2007 - 2013 Cadillac CTS-V: GM TechLink: Low Oil Pressure on V8 Engines

Subject: Low Oil Pressure on V8 Engines

Source: GM TechLink

Fig. 3

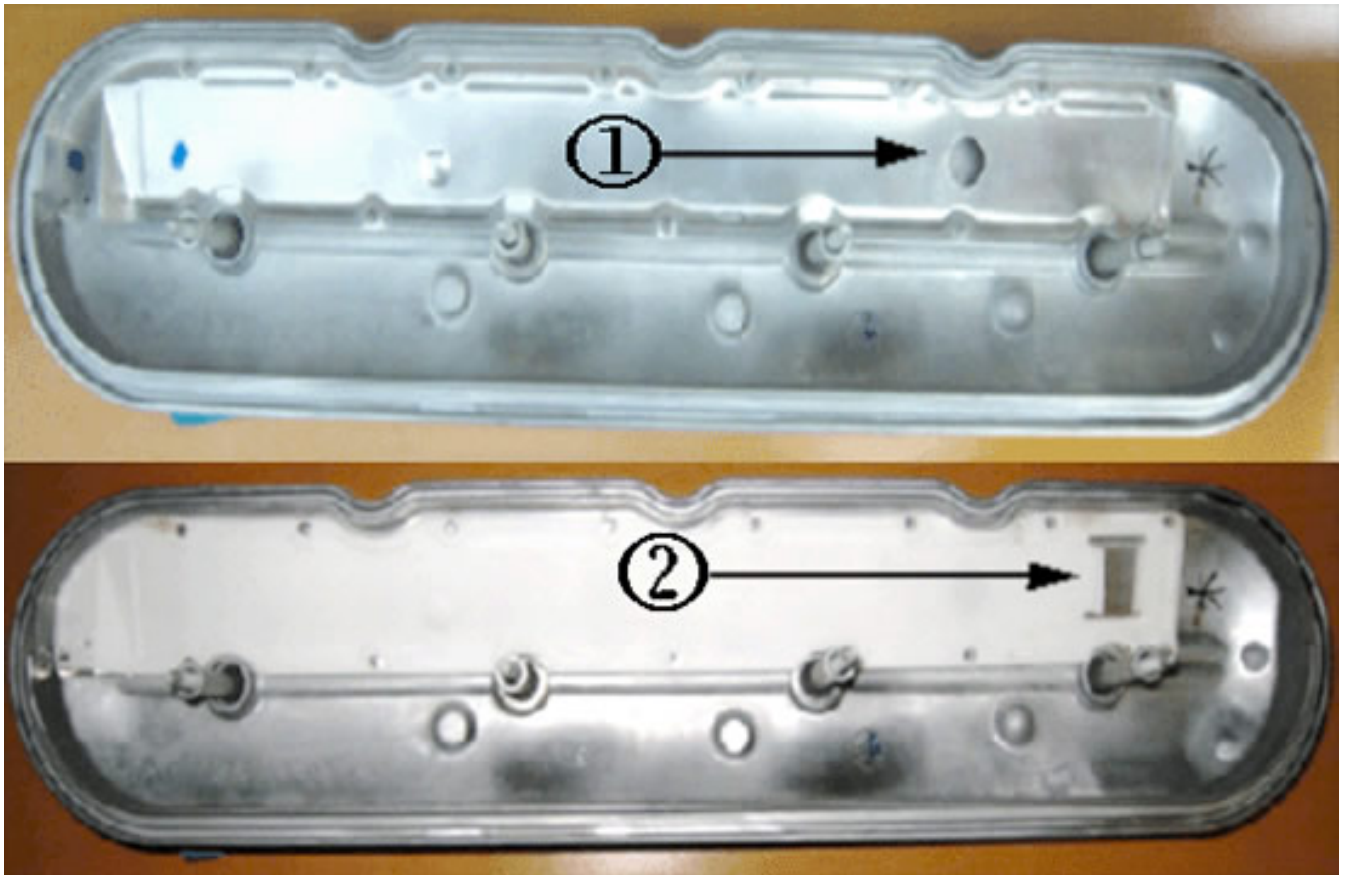
If the engine has been properly repaired and cleaned, inspect the left rocker cover (square baffle) (Fig. 3, #1 – old design; #2 – new design with square baffle) and verify that the baffles can hold water and do not leak. If any leaks

are found, clean and seal the edge of the baffle with RTV, if possible, or replace the valve cover. Thoroughly clean and dry the valve cover before installation and/or resealing.

In addition, change the engine oil and replace the oil filter with a PF48E filter.
